VENDOR DOCUMENT REVIEW STATUS

ENTERGY NUCLEAR MANAGEMENT MANUAL
EN-DC-149

Document No.: GZA Proj. # 01.0017869.92

Document Title: GZA/Theielsch Engineering Soil Resistivity Data for IP2 & IP3 AFW Bldg, IP2 SW Line 408

IP2/IP3 SOIL SAMPLE LOCATIONS

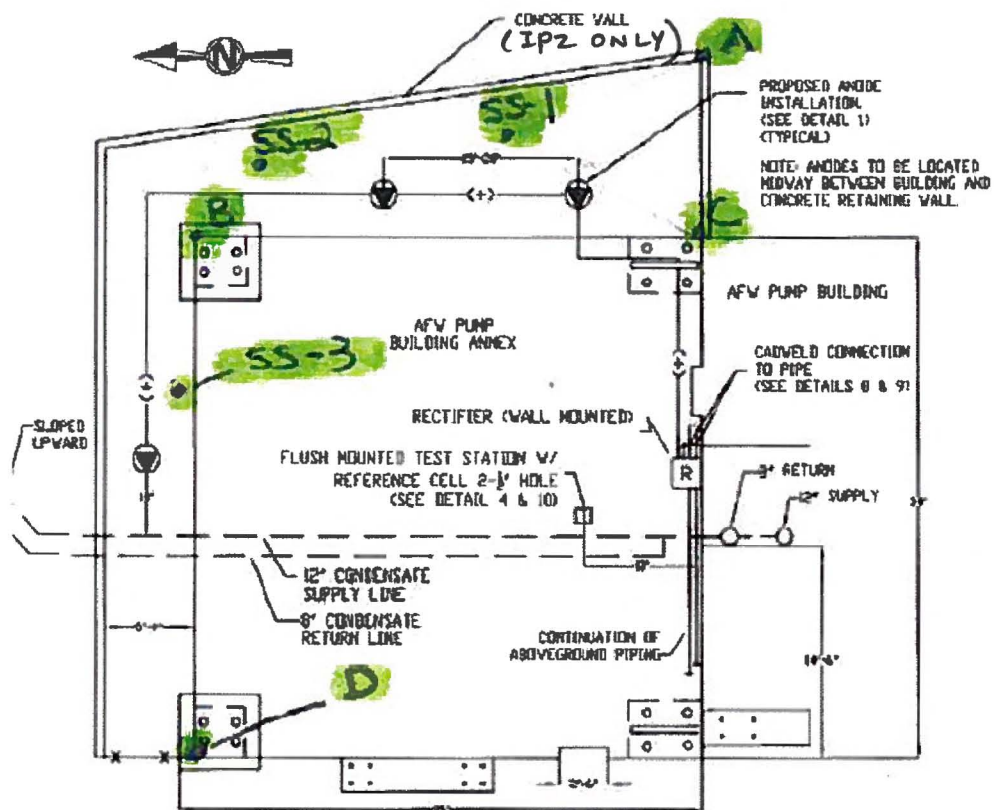
** SKETCH OF SOIL SAMPLE LOCATIONS ATT. RCL 5/31/12*
